## **APPENDIX D**

### **Time Concentration Plots for Water Quality Tracking Wells**

The Basin A Neck System (BANS) and Bedrock Ridge Extraction System (BRES) were installed to extract the contaminated groundwater flowing out of former Basin A and treat it to meet remediation goals at the BANS treatment plant. The migration pathways to these systems were the only known outlets for contaminated groundwater migrating from former Basin A. As discussed in Five-Year Summary Report (FYSR) Section 5.1.5.1, a migration pathway at the north end of former Basin A was identified for dieldrin and arsenic in the 2014 on-post plume mapping project.

Figure 4.29  
 A Sand Extent and Subcrop Map

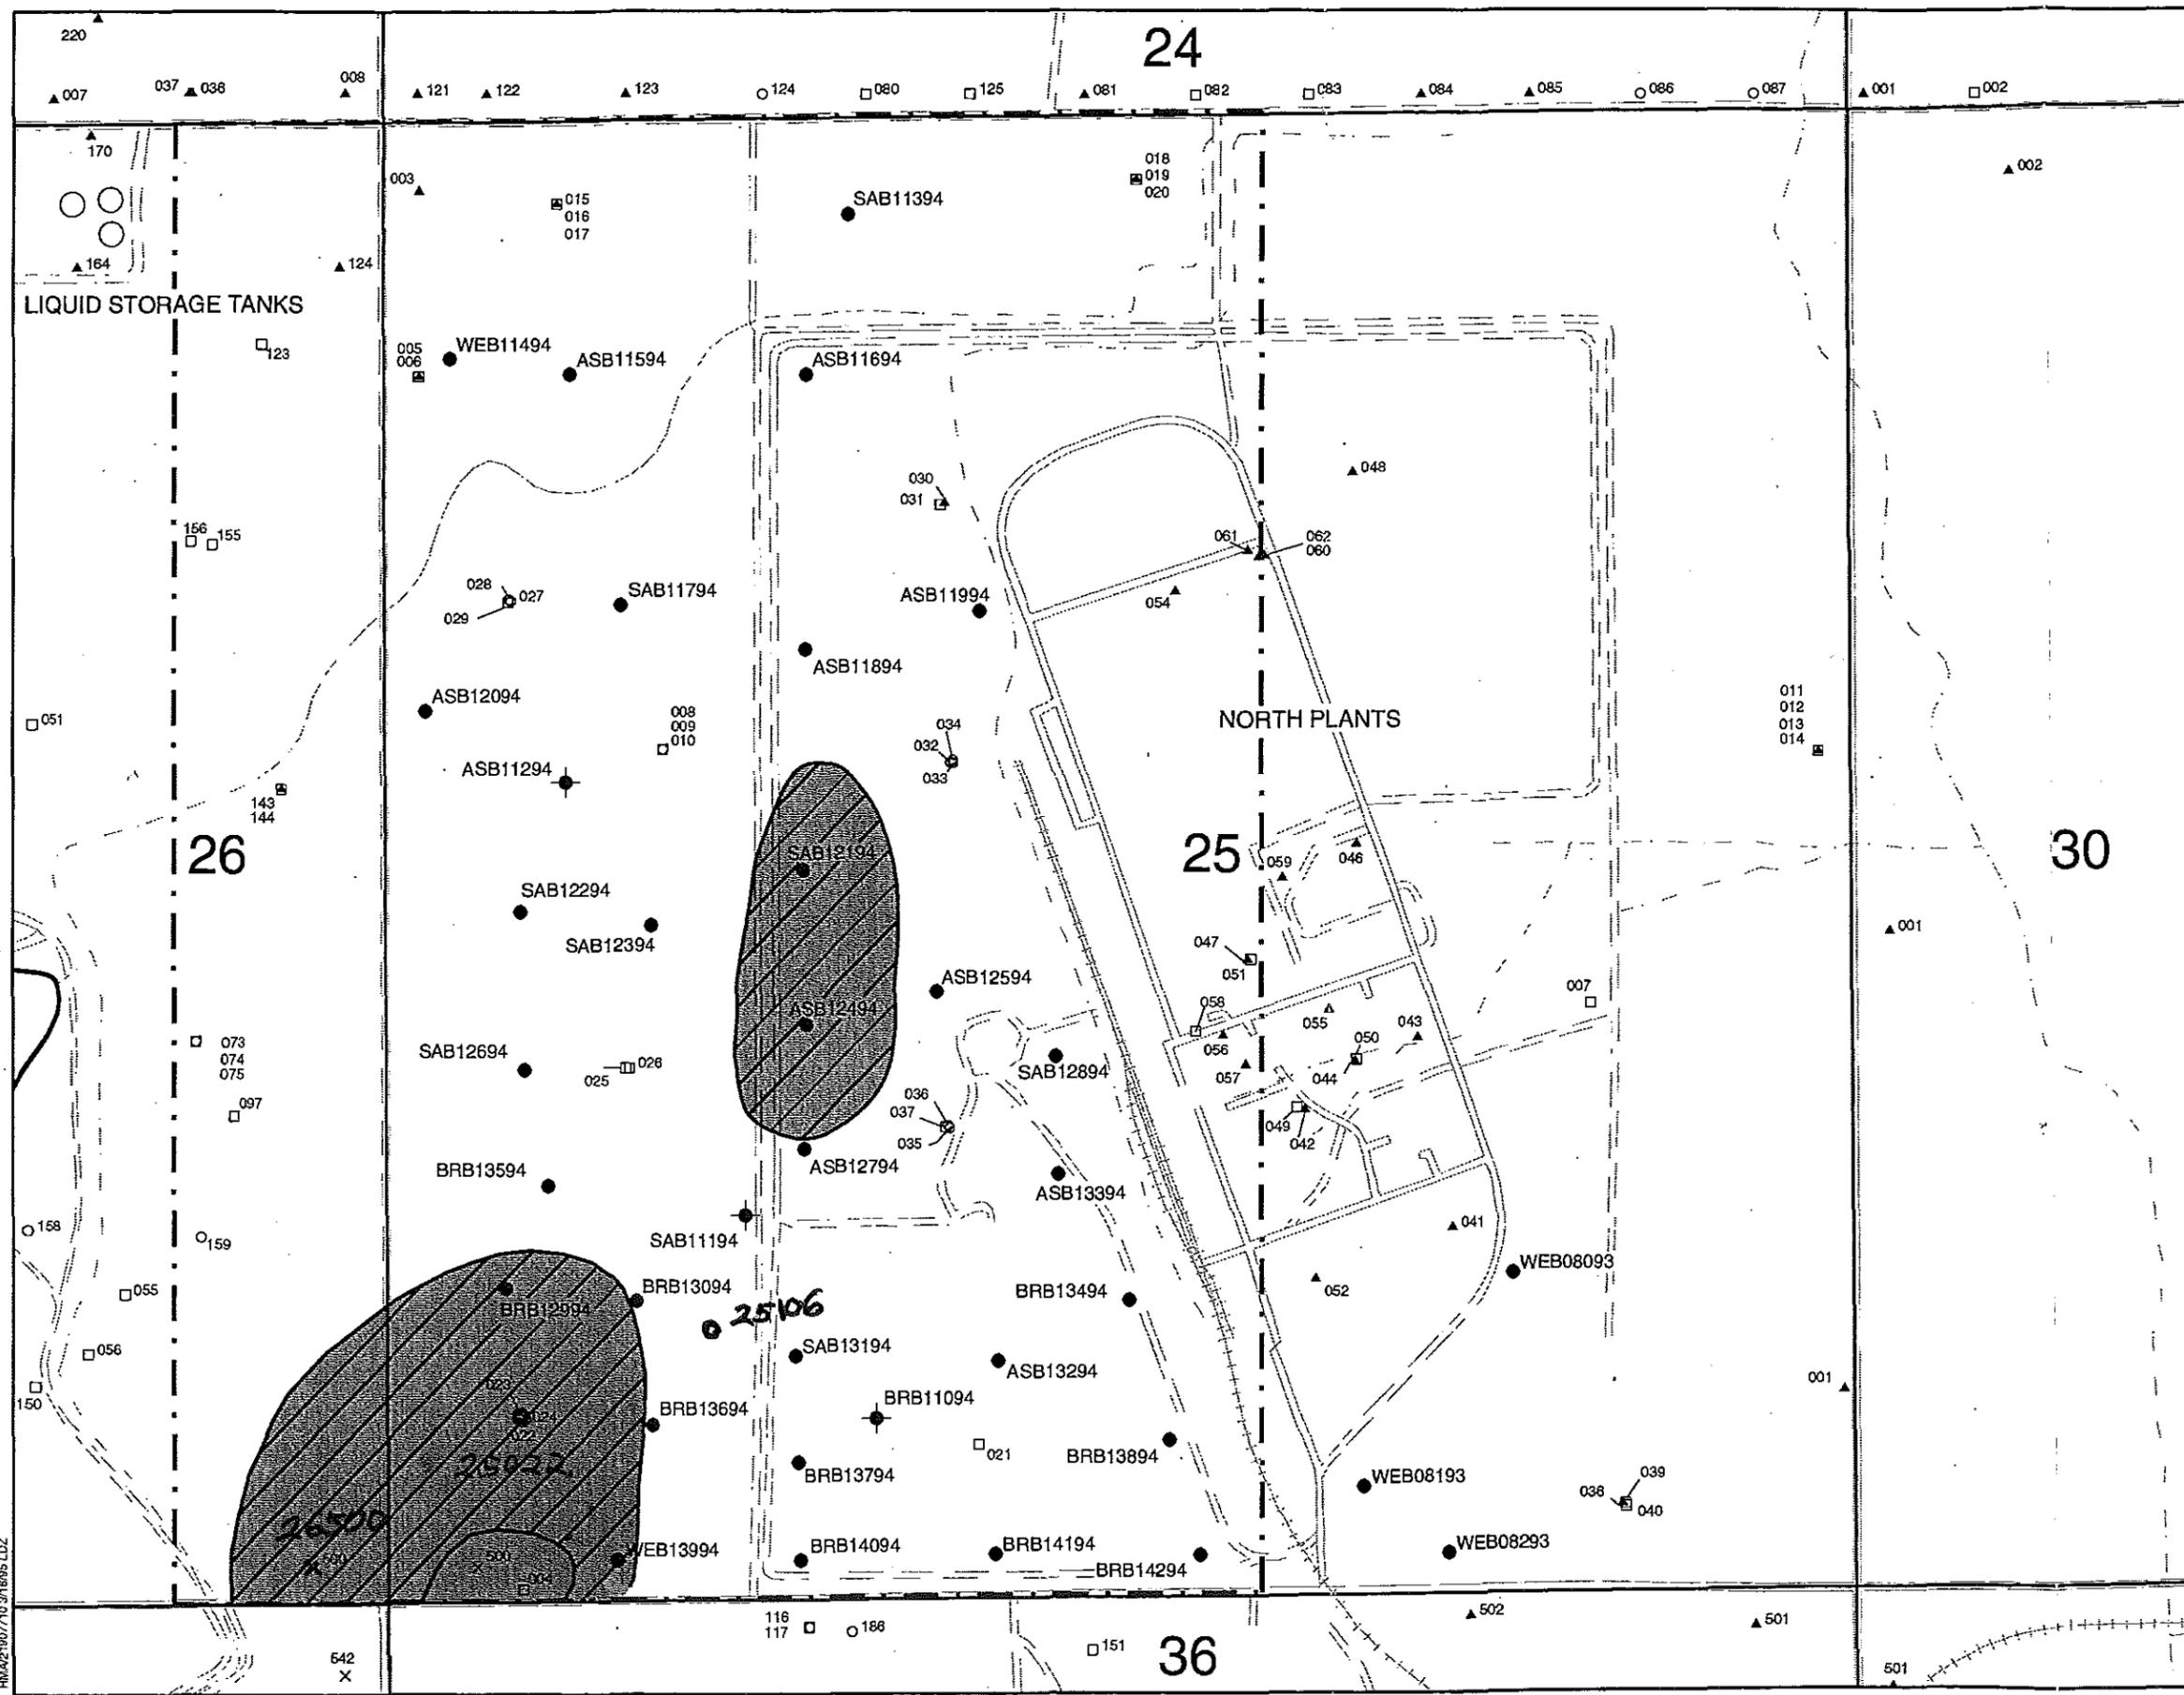
- d. The subsection titled “Dieldrin” indicates that a previously unidentified contaminant pathway exists in the sub-cropping Denver Formation north of Basin A. However, there is no information provided as to what wells were used to make this conclusion. Discovery of a new contaminant pathway out of Basin A constitutes new information which may have implications for remedy assessment. Therefore, consultation should be initiated with the Regulatory Agencies and a plan presented for evaluating this pathway.

- d. Well 25022 is located in the area where some of the groundwater contaminants migrated through subcropping Denver sandstones at the north end of Basin A, south of the ELF, and east of former Basins C and F. Dieldrin was first detected in well 25022 in 1987, and it was also detected in 1994. Thus, the presence of dieldrin in this area is not new. A description/explanation of the migration in this area adds to the understanding of the plume distributions, but does not materially affect the remedy assessment because the contamination has been present historically. Other wells where dieldrin has been detected in this area include 25106, 36112, and 36538. Additional evaluation of this migration pathway will be added to the FYSR.

Figure 4.17  
 Boring and Cross-Section Location Map  
 Section 25

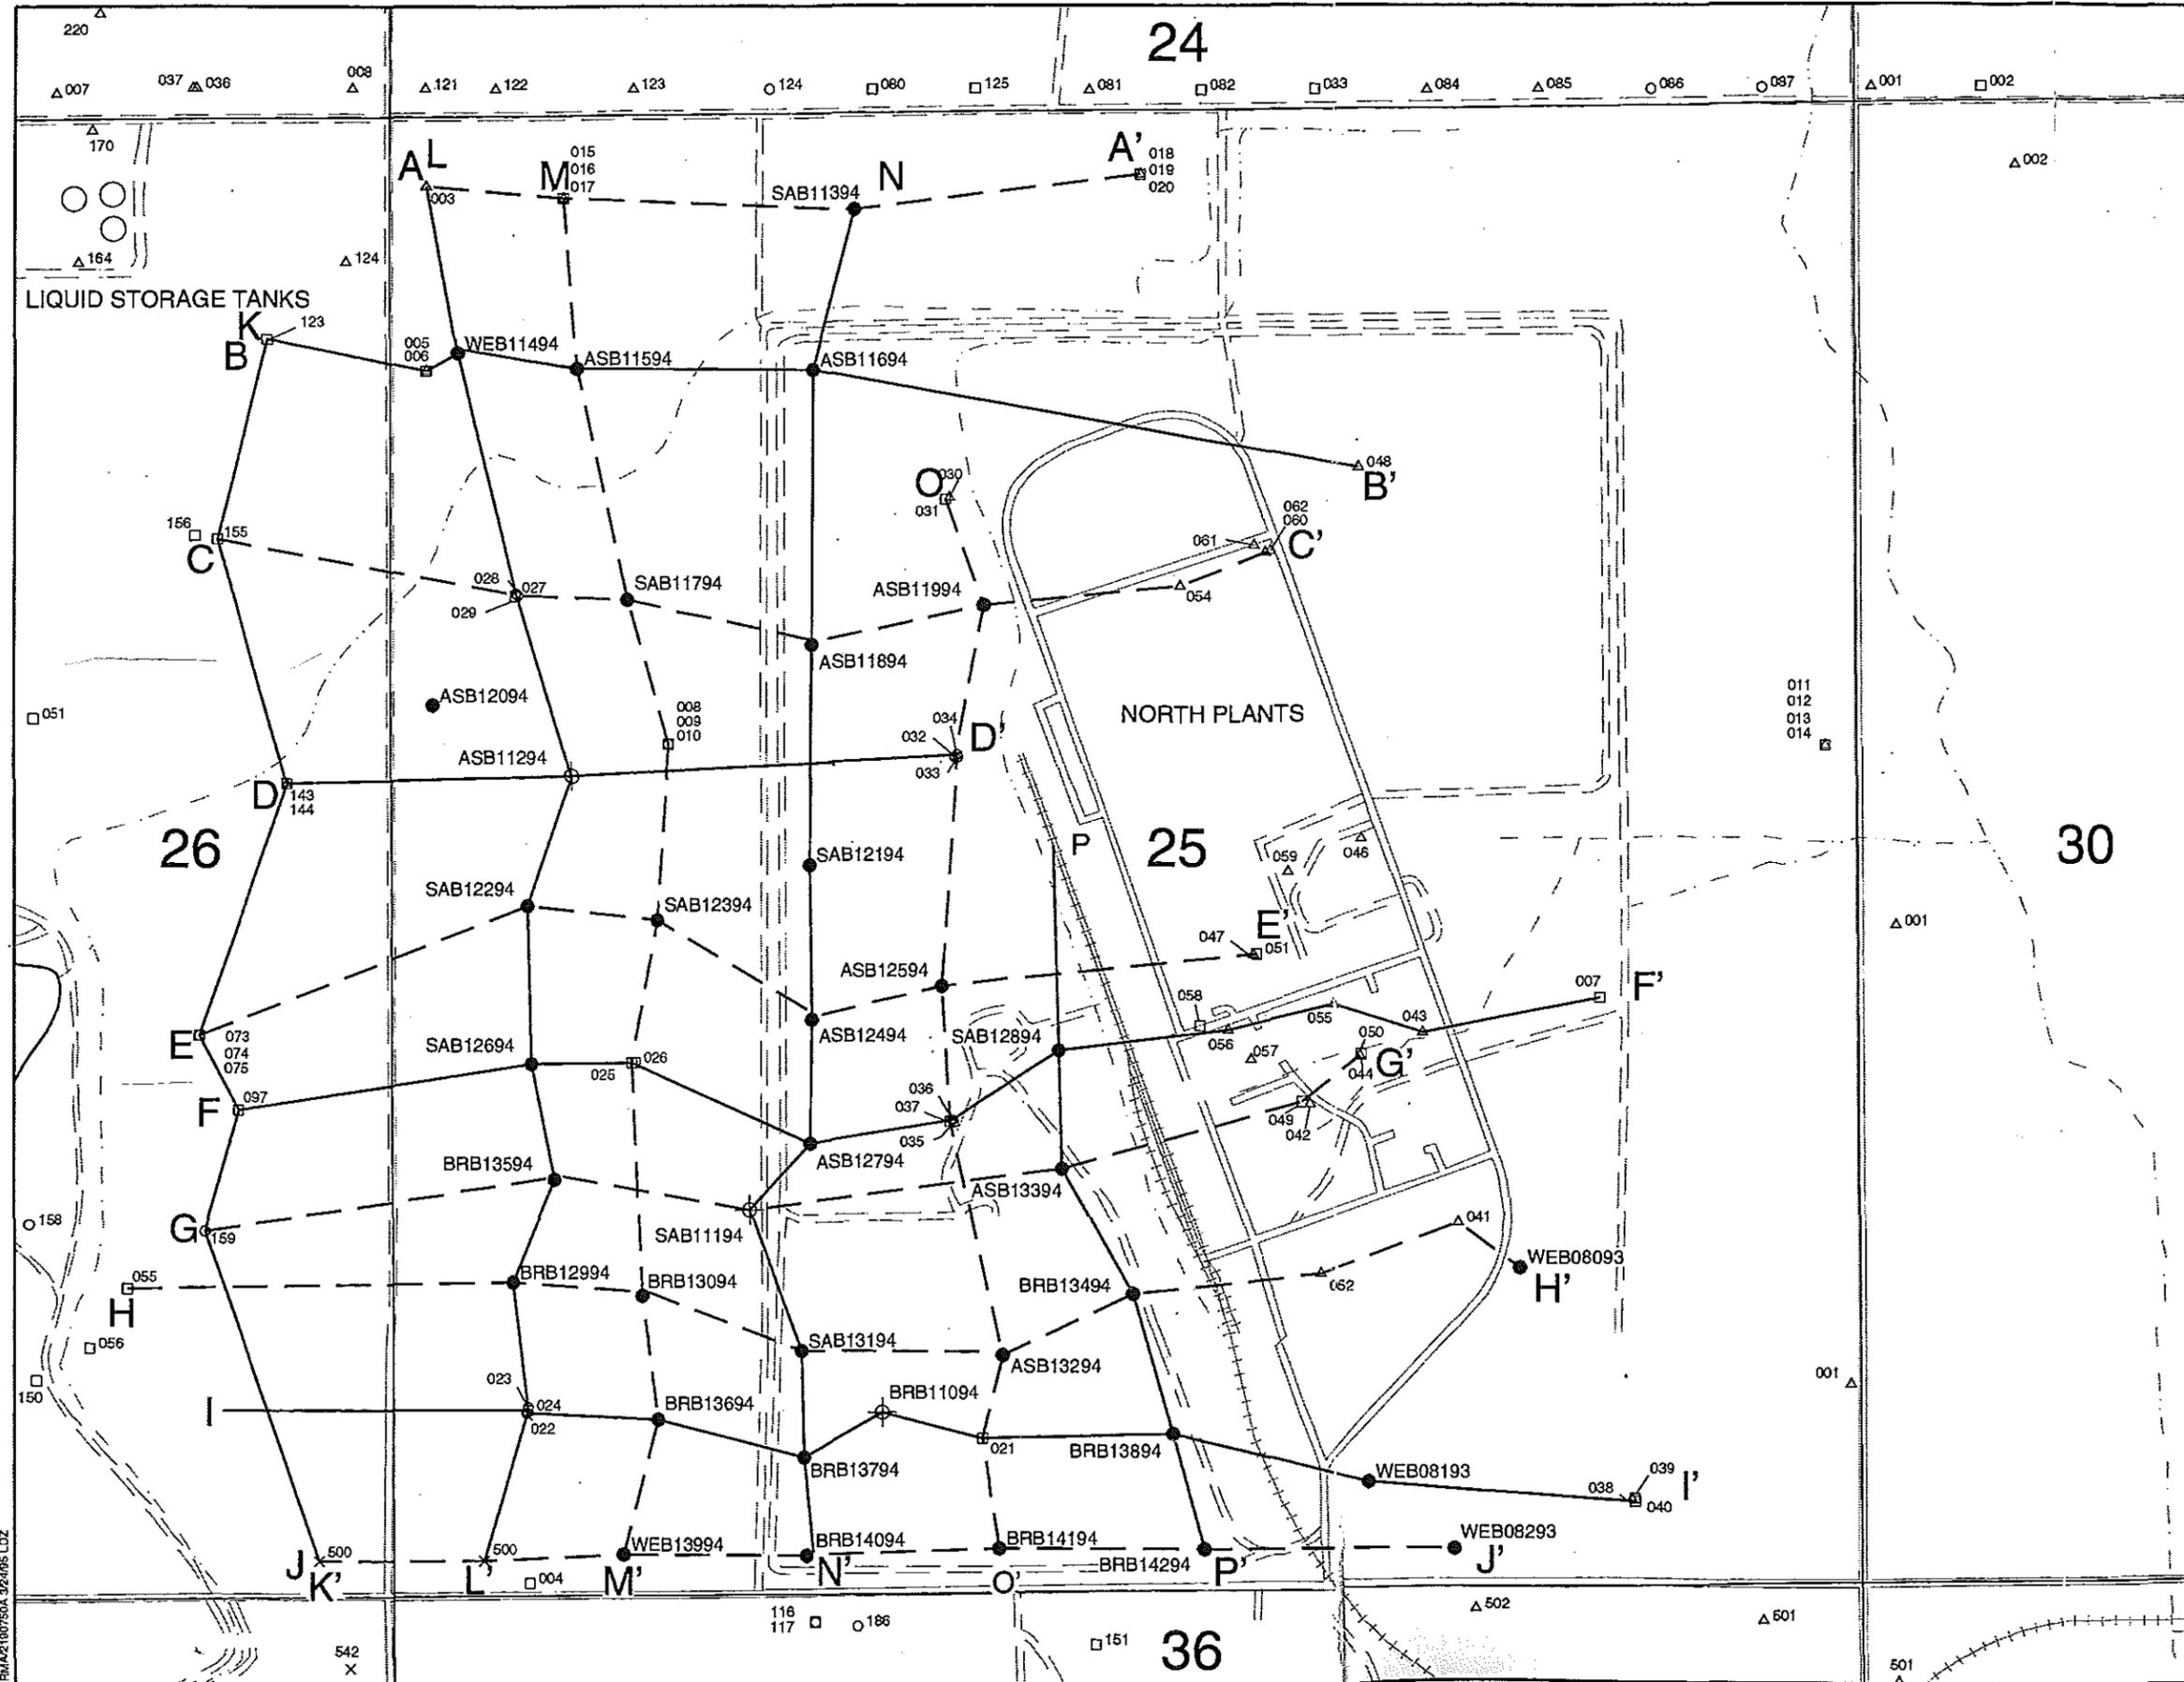
Cross sections for large areas of RMA were constructed in two reports that are relevant to the north Basin A pathway: 1) *White Paper, Evaluation of the Denver Formation at RMA* (MK 1994); and 2) *Final Landfill Site Feasibility Report for the Feasibility Study Soils Support Program* (HLA 1995). Both reports mapped the extent of the A Sandstone north of Basin A. Plate 2 and Figure 4.29 show the interpreted extent of the A Sandstone from these reports, respectively. Wells 25022 and 25106 are located upgradient of the ELF and have contained dieldrin and arsenic, and are shown on Figure 4.29. Plate 2 also shows the cross section locations from the MK report. Figure 4.17 shows the cross section locations from the HLA report.
